APPLICATION NO.	FILING DATE	FIRST NAMED INVENTOR	ATTORNEY DOCKET NO.	CONFIRMATION NO.
10/694,453	10/27/2003	Vladimir I. Gorokhovsky	AME-10/694,453T	2518
46271	7590	05/30/2006	EXAMINER	
JEAN KYLE			MCDONALD, RODNEY GLENN	
P. O. BOX 2274			ART UNIT	
HAMILTON, MT 59840-4274			PAPER NUMBER

<b>Office Action Summary</b>	<b>Application No.</b> 10/694,453	<b>Applicant(s)</b> GOROKHOVSKY, VLADIMIR I.	
	<b>Examiner</b> Rodney G. McDonald	<b>Art Unit</b> 1753

## **DETAILED ACTION**

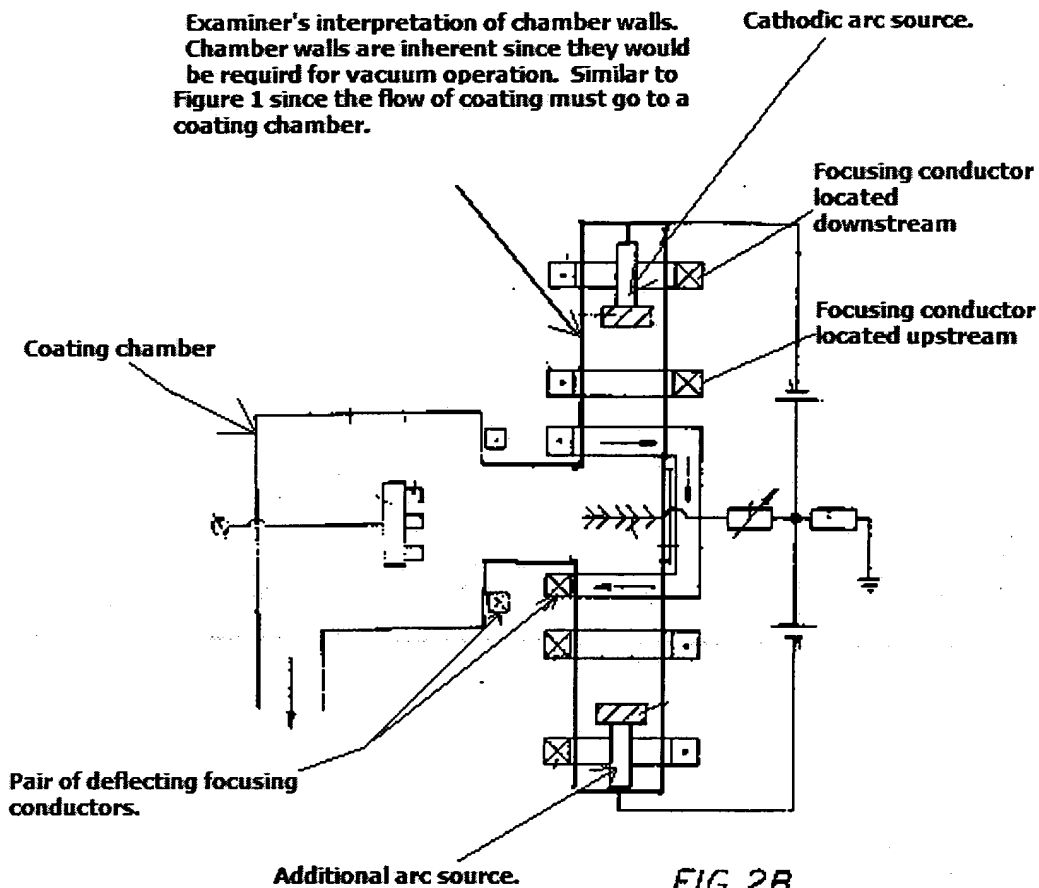
Regarding claim 44, Gorokhovsky teach an apparatus for the production of coatings in vacuum. (See Abstract) In fig. 1 Gorokhovsky teach at least one filtered arc source comprising at least one cathode 12 contained within a cathode chamber. The filter is element 9 with fins. (See Fig. 1) At least one anode 9 is associated with the cathode for generating an arc discharge. (See Fig. 1; Column 4 lines 3-6) A plasma duct 1 is in communication with the cathode chamber and with a coating chamber 3 containing a substrate holder 4 for mounting at least one substrate 5 to be coated the substrate holder 4 being position off an optical axis of the cathode 12. (See Fig. 1; Column 4 lines 1-3) At least one pair of focusing conductors 7, 8 is disposed adjacent to the cathode and the plasma duct, along upstream and downstream sides of the cathode, for focusing a plasma flow from the cathode to the plasma duct 9. (See Fig. 1; Column 3 lines 67-68; Column 4 line 1) Gorokhovsky teach a modification of Fig. 1 in Fig. 2B shown in the drawing below.

The chamber walls as understood by the Examiner would be located at the inside of the magnets similar to Fig. 1 and would lead to a coating chamber similar to Figure 1.

There is at least one pair of deflecting-focusing conductors 2, 15 disposed adjacent to the downstream side of the cathode and opposite sides of the plasma duct 9, generating a deflecting magnetic field for deflecting a plasma flow from the arc source into the plasma duct and a focusing magnetic field for focusing plasma flow along the plasma duct. (See Fig. 2B, Fig. 1; Column 4 lines 26-30) The deflecting field would inherently couple with the focus field to direct plasma. At least one metal vapor plasma source comprising material to be evaporated (labeled additional arc evaporation source

by the Examiner; The Examiner interprets that the metal vapor source includes a metal cathodic arc evaporation source.) comprises a material to be evaporated and is installed in the plasma duct "near" a converging area of the focusing magnetic field where the deflecting magnetic field is the smallest and is disposed off the optical axis of the chamber. (See Fig. 2B; Fig. 1; Column 4 lines 31-36) At least one pair of focusing conductors are disposed adjacent to the metal vapor source and the plasma duct on upstream and downstream side of the metal vapor source for focusing plasma flow from the metal vapor source to the plasma duct. (See Fig. 2B) Metal vapor propagates toward the substrate along magnetic field lines of the deflecting magnetic fields. (Column 4 lines 25-30)

Regarding claim 45, there is at least one metal vapor plasma source disposed in the coating chamber in opposition to the filtered arc source. (See Fig. 2B) Here the Examiner is interpreting that the at least one metal vapor plasma source covers a cathodic arc evaporation source.

Regarding claim 47, the at least one metal vapor plasma source is coupled to the cathode and disposed off an optical axis of the substrate holder. (See Fig. 2B)
